CITY OF ST. AUGUSTINE CORRIDOR REVIEW COMMITTEE

A G E N D A

THURSDAY, MAY 4, 2023 - 2:00 PM

DSEC HP2023-0022
169 King Street
May 4, 2023

Overall Site Plan
1/8" = 1' - 0"

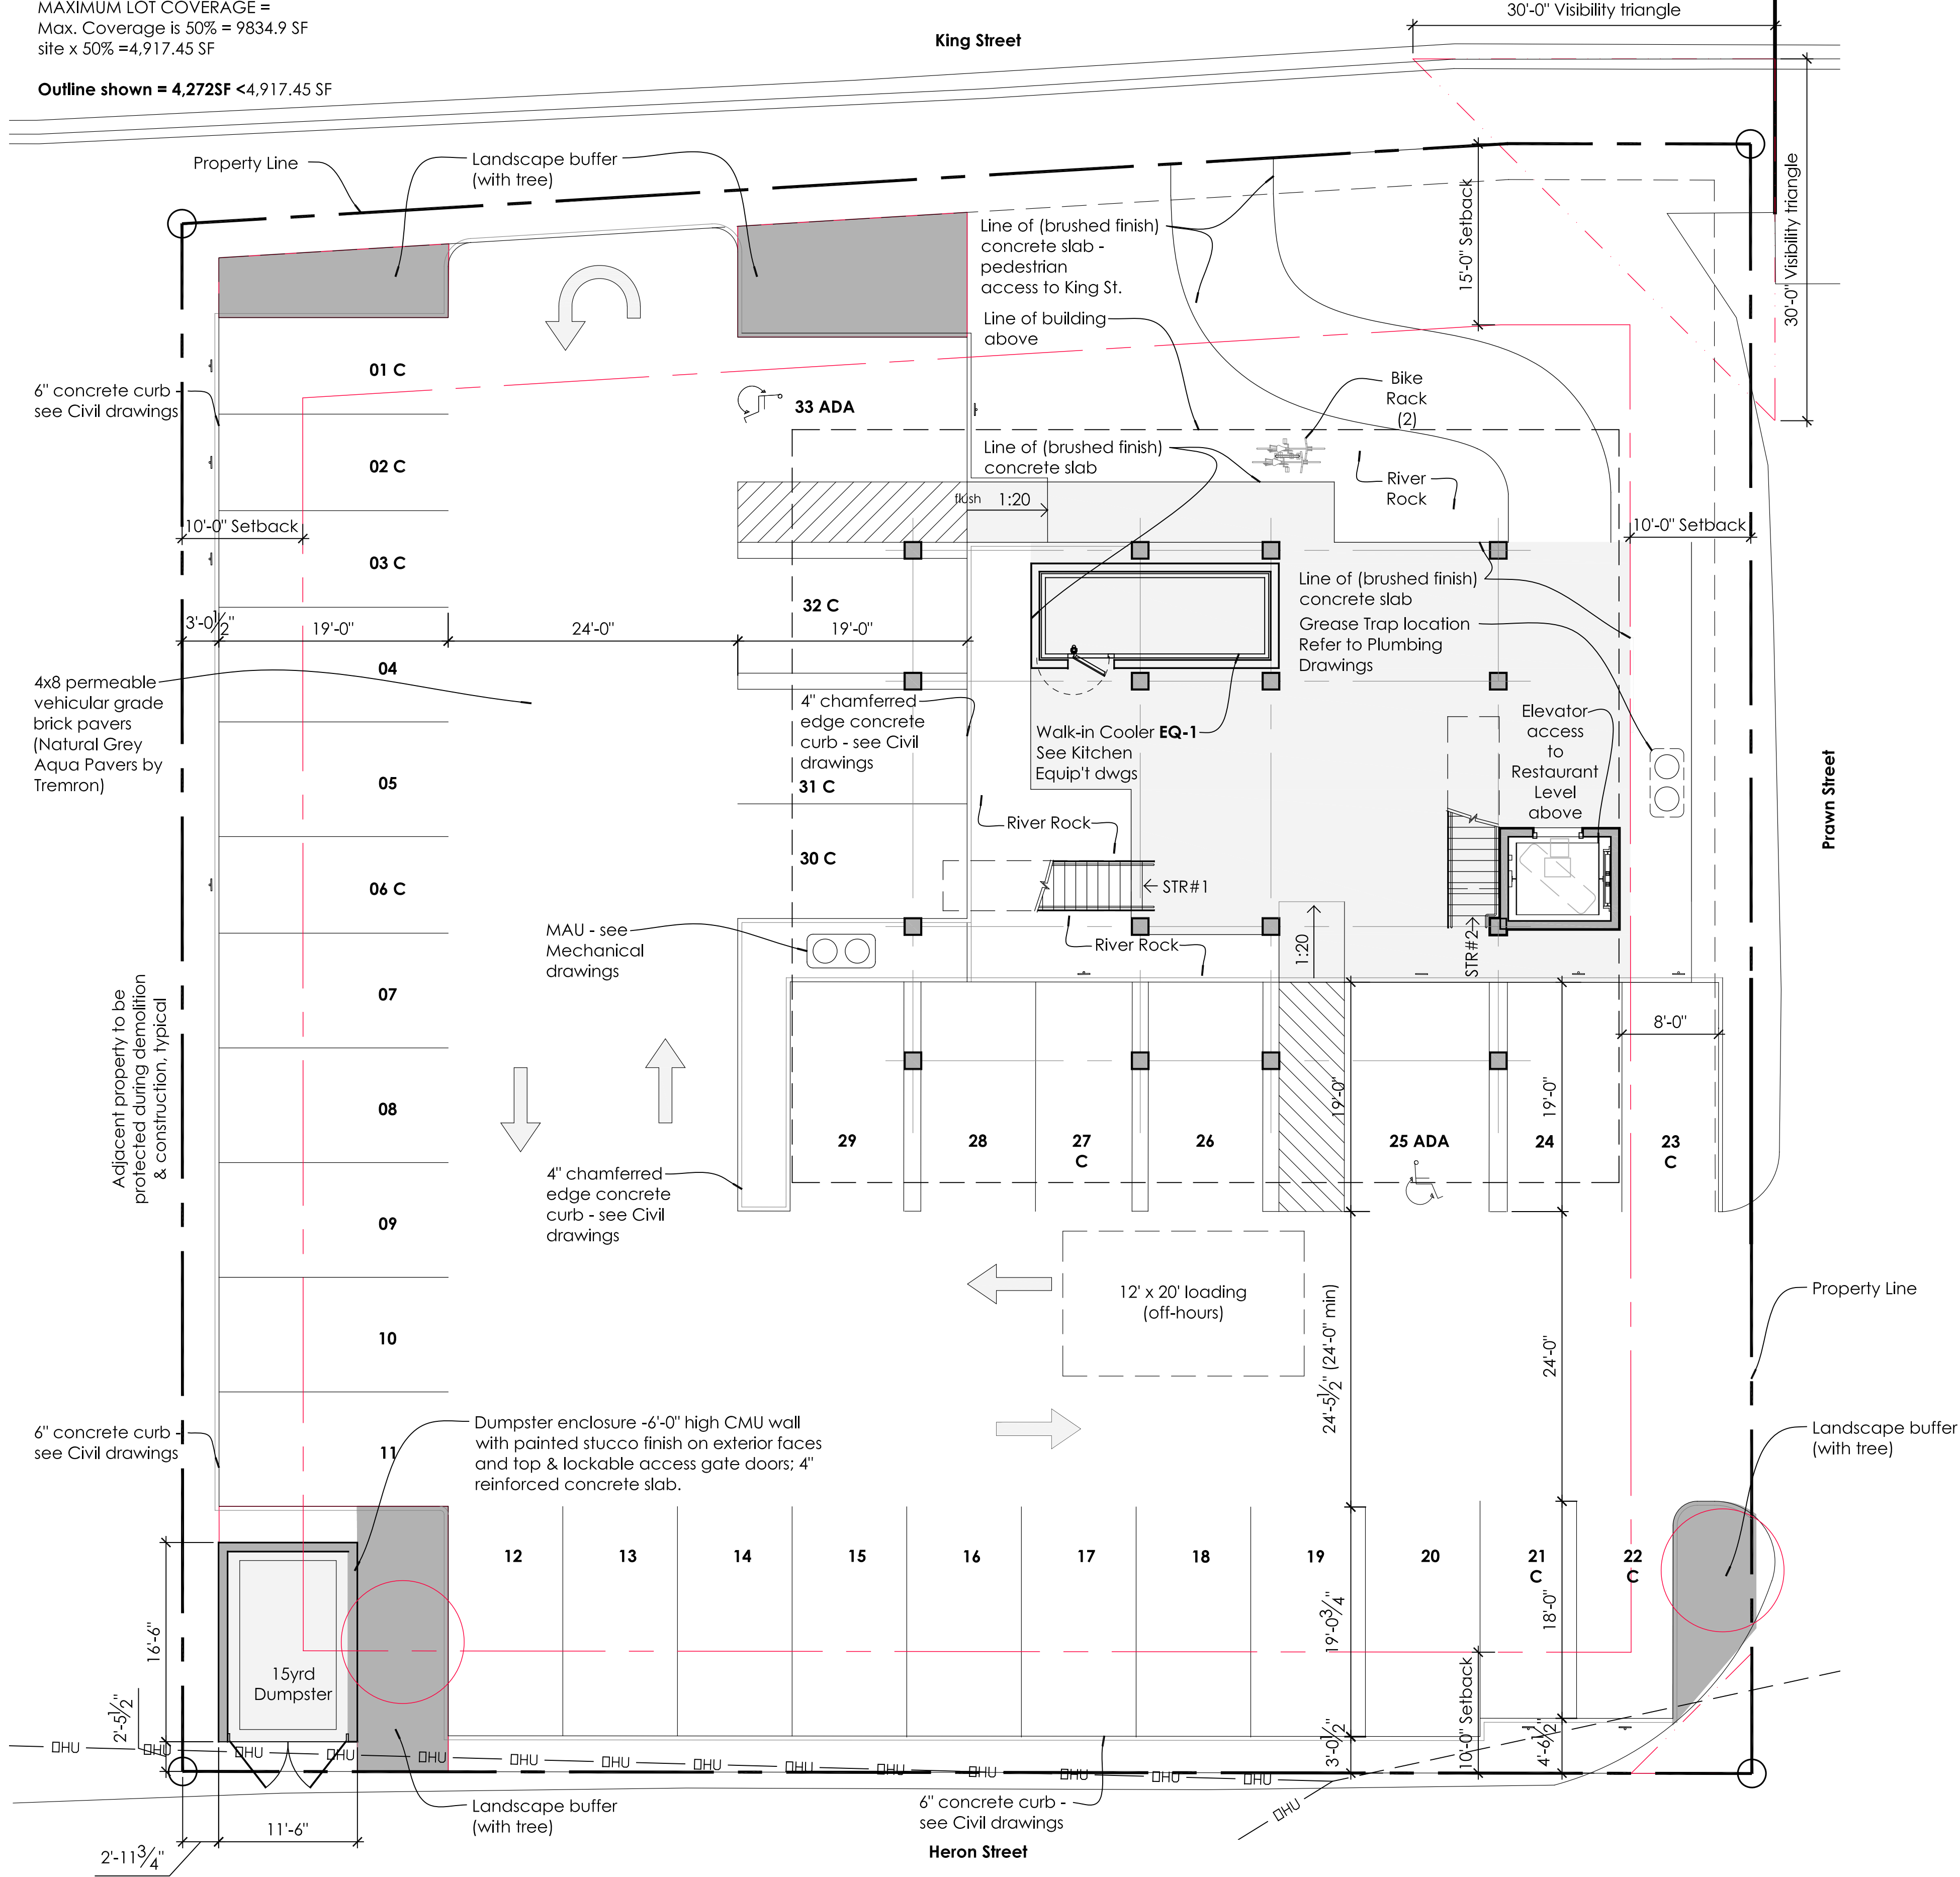
1. The required maximum front setback according to the King Street Design Standards for Entry Corridors (DSEC or Standards) is 15' which may be expanded to 20' for a maximum of 50%. While setbacks from the roof eave are not clearly marked on the plans provided, the applicant has stated that there is 21' 6" from the roof eave at the farthest point, though the nearest setback measures to 17' 11". The CRC may approve a modification of up-to 19.5' for the maximum allowed setback (30% greater than the 15' allowed per the Standards) if the request meets modification review criteria detailed in sec. 3.7.5 of the Standards. Additional information from the applicant is needed to determine whether at least 50% of the building's frontage is within the maximum allowed modification, otherwise, to maintain the setbacks as submitted, (greater than 19.5') the applicant can apply for a variance from the Planning and Zoning Board (PZB).

2. The building frontage requirement is 70% of the site frontage along the corridor. With setbacks as proposed, the current measurement is 0%. If the building were brought up to an approvable setback from the property-line, the building frontage as proposed would constitute approximately 56% of the site frontage (measured from roof eave to roof eave) which is outside the scope approvable by the CRC through the modification process (62.3%). A variance application from the PZB would be required for approval of the building frontage as presented.

9. Parking placement appears to be consistent with the DSEC which requires parking to the rear of the structure but provides for parking along the side of the property not being utilized for building frontage. Requirements for utilizing side-parking visible from King Street include a Street wall in addition to landscaping. While landscaping requirements related to the parking area appear to be met, a street-wall should be added to screen the parking lot from King Street. Bringing the street wall across the property frontage with an opening for pedestrian access may help to accentuate the entry-way and mitigate the distance of the building from the street.

13. The proposed dumpster enclosure shall adhere to City Solid Waste requirements as detailed in the Standards. The proposed tree adjacent to the enclosure as seen in the Landscape plan may interfere with the requirement that the dumpster be clear of obstructions a minimum of 20' in height.

- **A street wall be added along King Street to, at minimum, screen the visible portion of the parking lot**
- **Proposed exterior lighting for walkway and parking areas shall conform to the requirements set forth in the Standards**
- **The design elements that do not meet the DSEC as determined by staff require approval by the Planning and Zoning Board or have been modified to a threshold which can be approved by the CRC and meets the review criteria under section 3.7.5.**

North Elevation
1/4" = 1'-0"

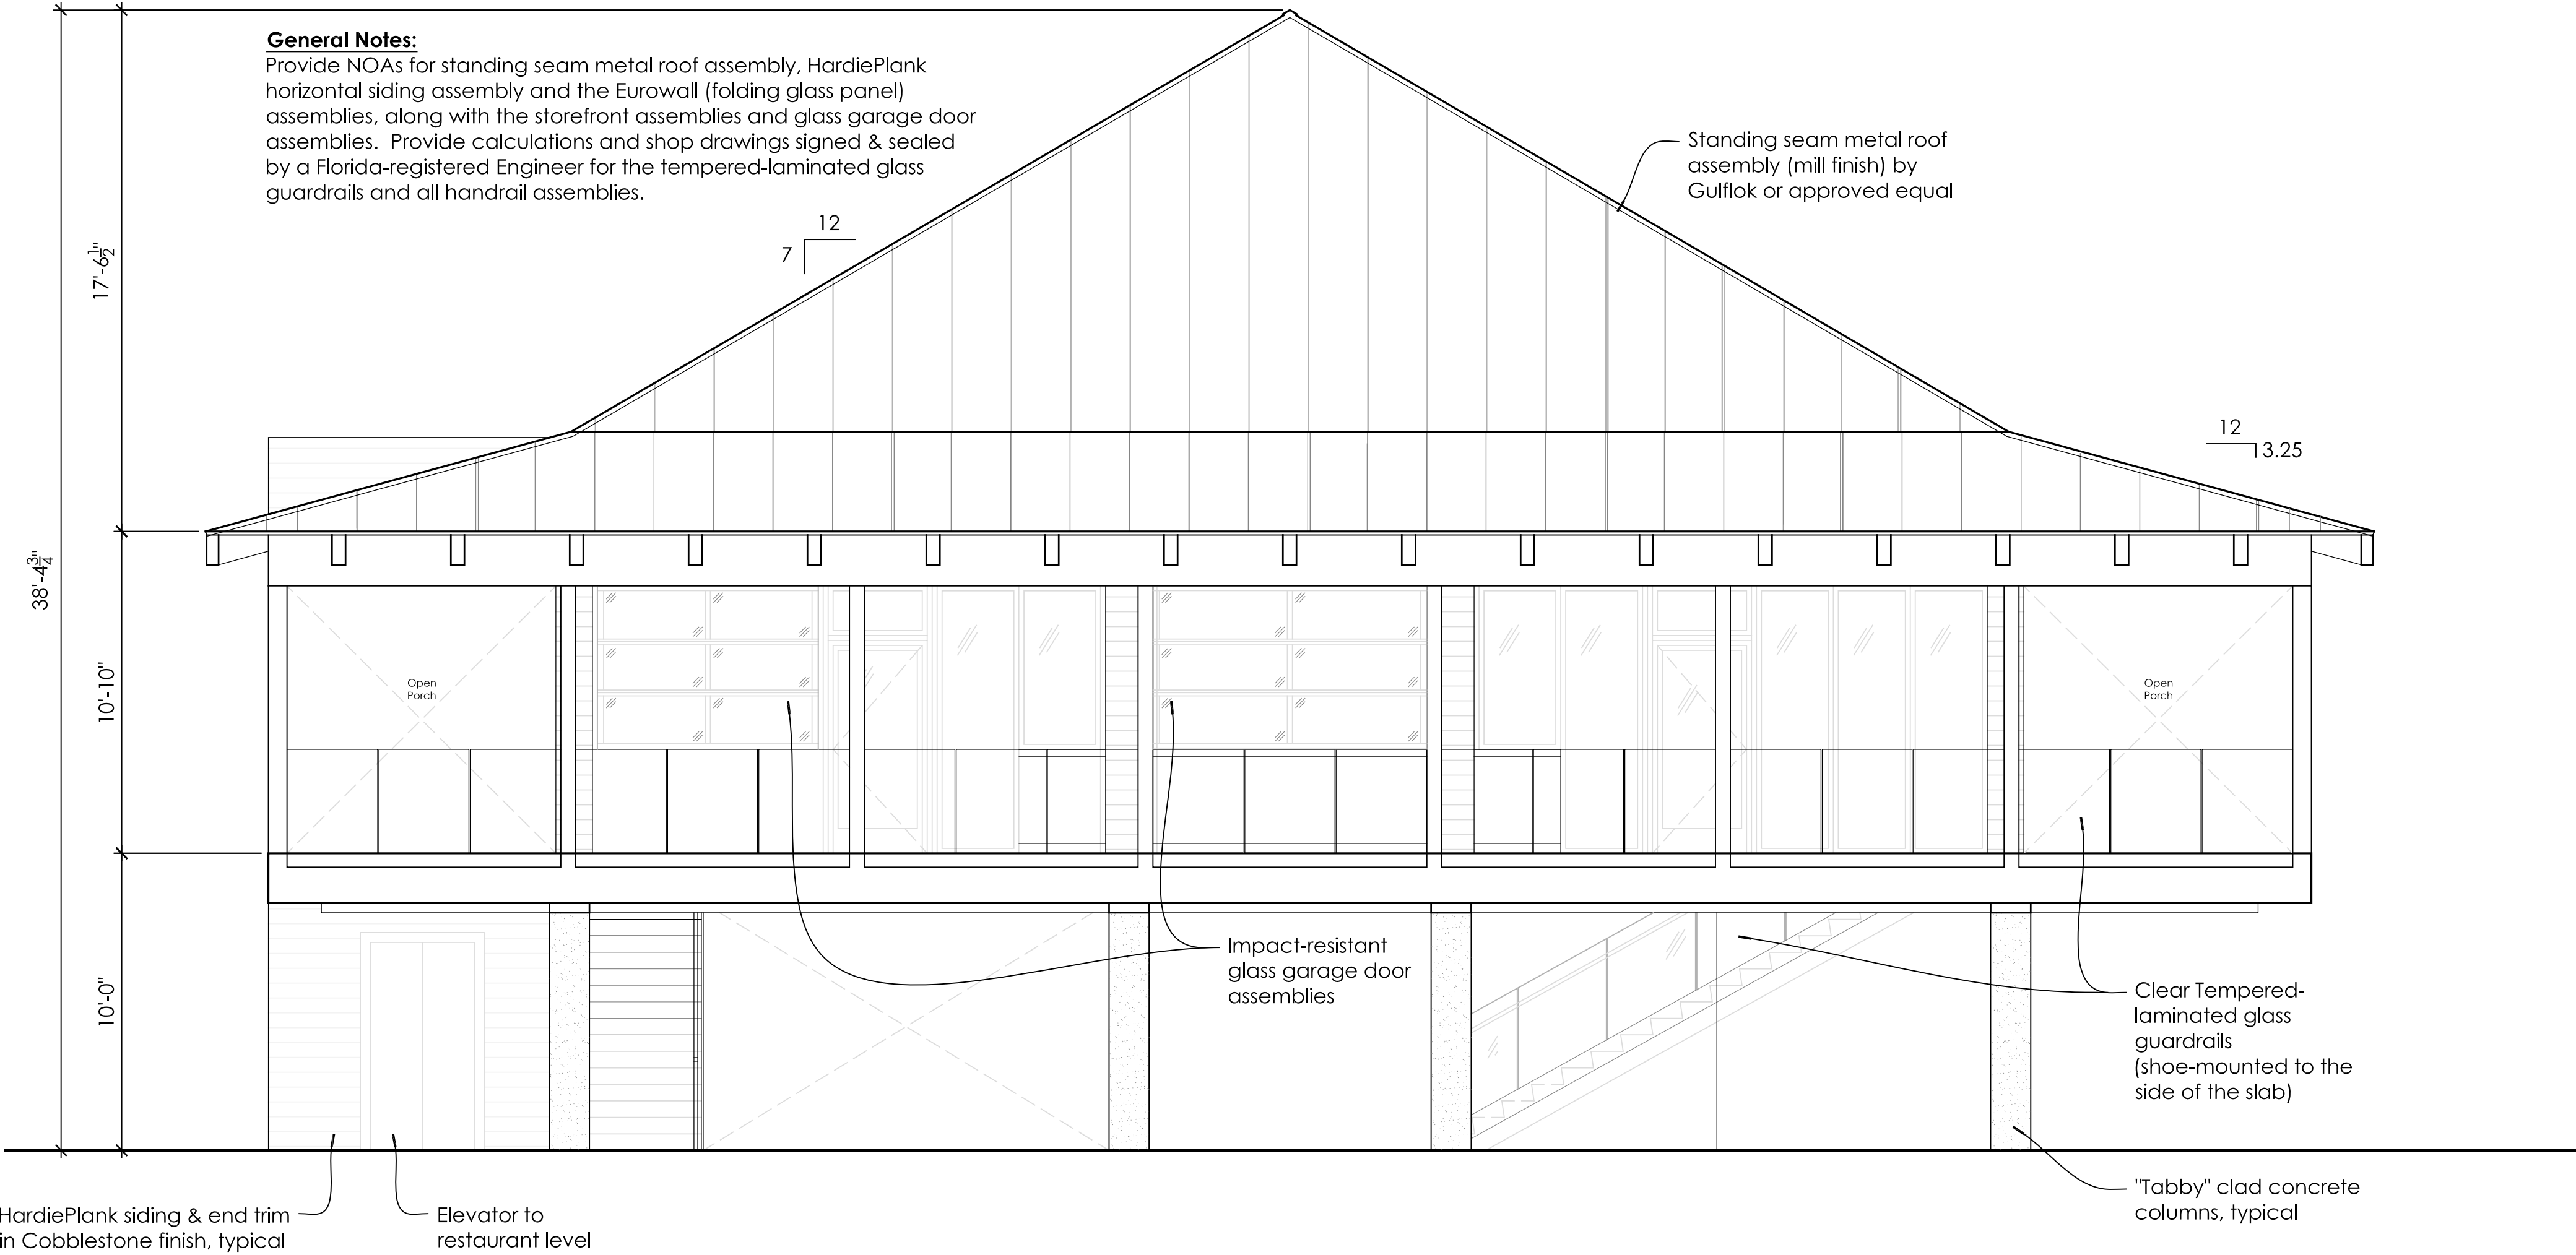
1. The proposed structure is a modern architectural style elevated on concrete piers with a low-pitched metal roof, exposed rafter tails, wrap-around porch with glass guardrail, and glazed storefront windows and garage doors. Architectural elements such as the tabby-covered piers and Hardie plank siding give a slight nod to the old-Florida maritime industrial feel which would have been prominent along the San Sebastian River. The heavy glazing with aluminum framing and metal roof adds to the industrial feel of the structure and is softened by extensive landscaping along King Street. Contemporary architectural design is permitted if the design respects the scale and character of the district.

4. According to the DSEC, exterior materials should be consistent with the architectural design of the building. The applicant should provide further details on the overall intent of the design and how the exterior materials including the Hardie Plank siding, tabby concrete, and industrial-style glazing are consistent with the architecture of the corridor and meet the intent of the Standards as detailed in Section 1.
